8. Trust Land Survey 2024 Emerald Subdivision; 2024-066
Fixed Height, LLC / Alaska Mental Health Trust Authority
Emerald Street & Fern Street
Salamatof Area / Nikiski APC

ITEM #8 - PRELIMINARY PLAT TRUST LAND SURVEY 2024 EMERALD SUBDIVISION

KPB File No.	2024-066
Plat Committee Meeting:	July 22, 2024
Applicant / Owner:	Alaska Mental Health Trust Authority, Anchorage, Alaska
Surveyor:	Buku Saliz / Fixed Height LLC
General Location:	Nikiski / Nikiski APC

STAFF REPORT

Vicinity Map

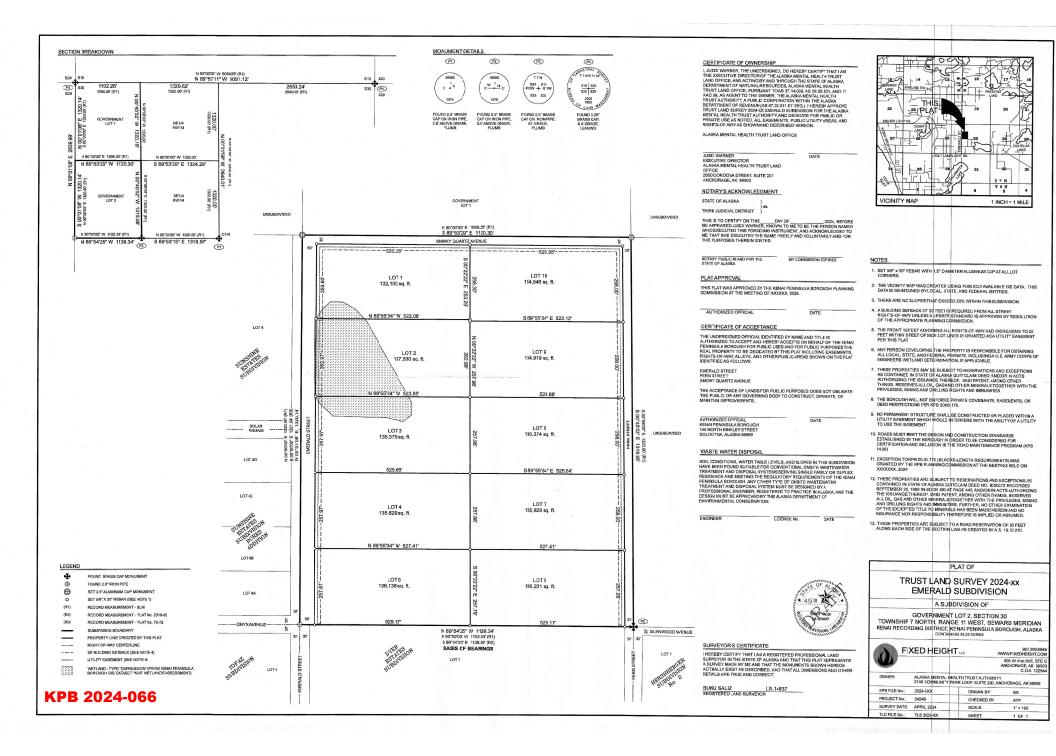
Add Miller Loop Rd to the south, Island Lake Rd to the north, and Holt Lamplight Rd to the east Label Island Lake and Kidney Lake

Pipeline Rd is on upper tier to the east, lower part is Alexander Rd and incorrectly labeled Add the missing section numbers to the map

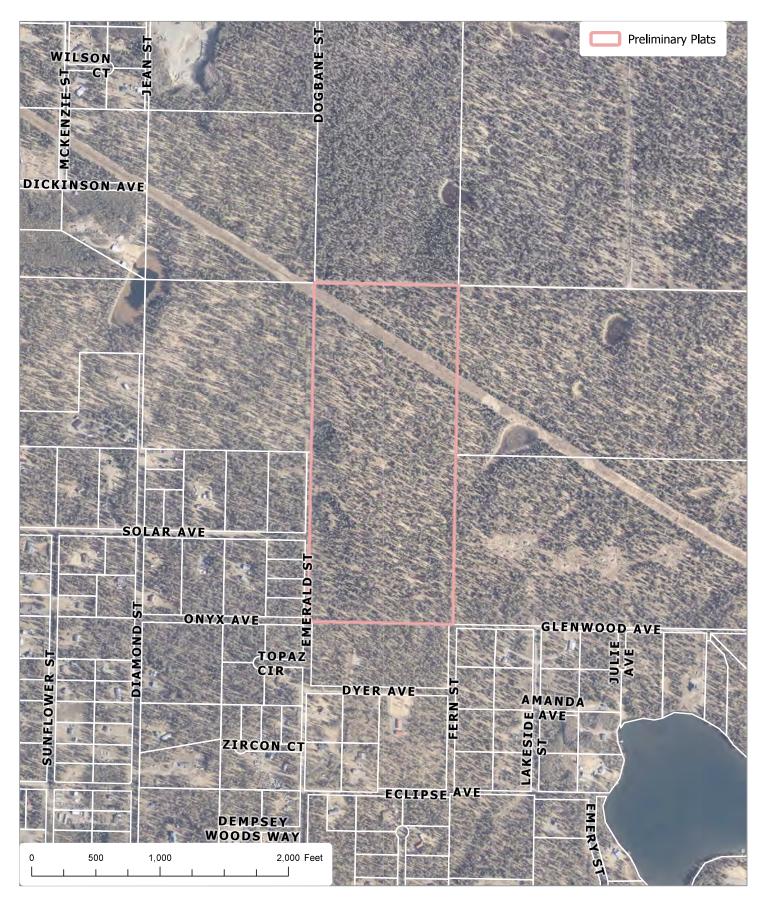
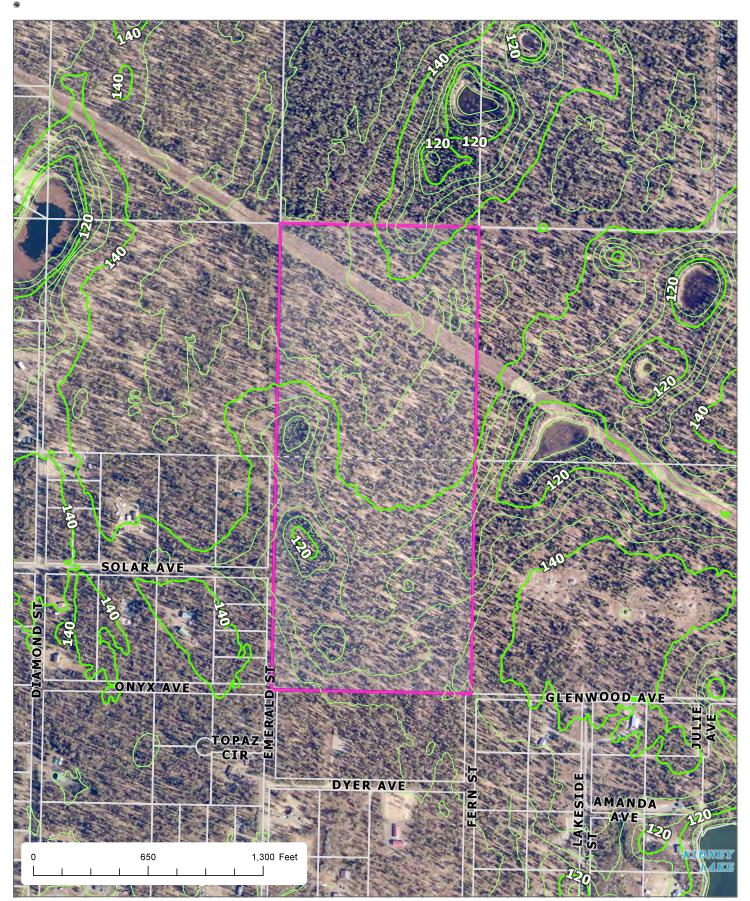
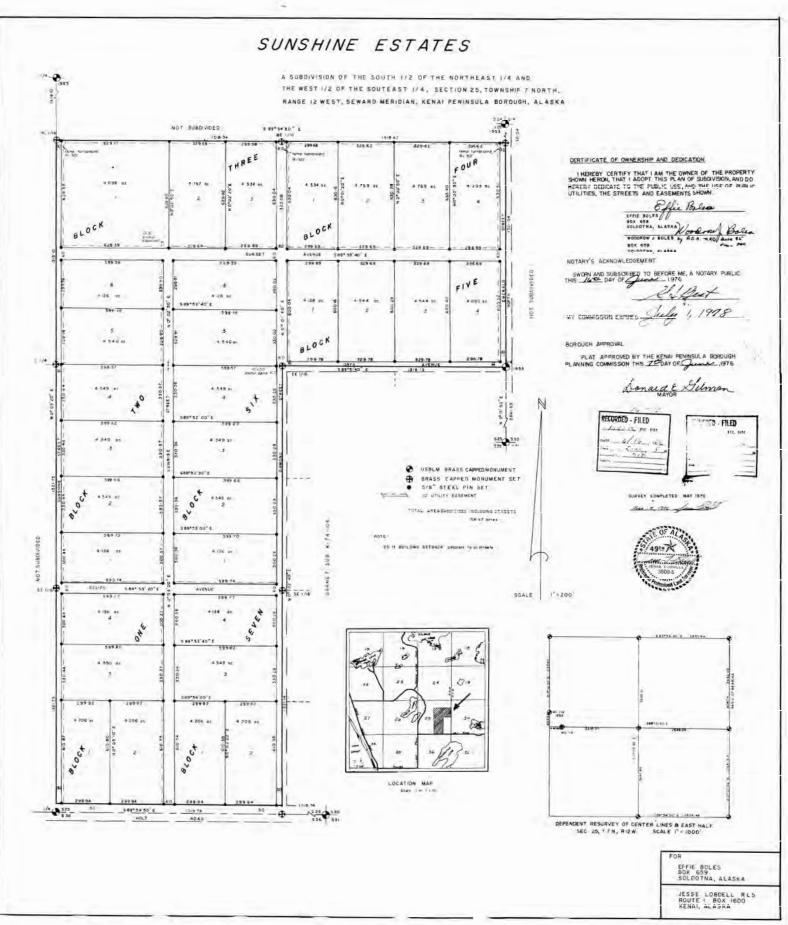
- Add the date of July 22 to the Plat Approval
- Add block numbers to the lots to the west and southeast
- Additional as below

- Roads must meet the design and construction standards established by the borough in order to be considered for certification and inclusion in the road maintenance program (KPB 14.06).
- Plat notes 7 and 12 appear to be the same, please check.
- Notes 3 and 11 can be removed from the final plat.

Add the KPB number of 2024-066

Title has 2024-XX, either remove the xx or complete with numbers

Check total acreage as staff came up with a different total

Add 'dedicated this plat' to the right-of-way dedications

Add a 30' road dedication along the south end of the plat, get with Addressing for correct name Add the section line easement going north and south of the subdivision Add width of Solar Ave

Add block numbers to the lots to the west and southeast

Add road on south and get with addressing for correct name

Staff recommendation: comply with 20.60.110. Add bearing and measurement to line at southern point between proposed Lots 1 and 10. Perhaps consider using a line table to clarify detail.

Staff recommendation: comply with 20.60.150. Remove 20' easements within 5' of lot lines in the south at corners of new road dedication but place them along lot lines in the north and south where lots join in the center of the plat along the dedications.

Staff recommendation: comply with 20.60.190. Update the date in the Plat Approval to July 22, 2024. Add "And Dedication" to the Certificate of Ownership. Add name of new dedication in the south to the list of names in the Certificate of Acceptance. Remove "XX" in Certificate of Ownership or assign numbers.

Staff recommendation: comply with 20.60.200. Provide cap detail for set monuments.
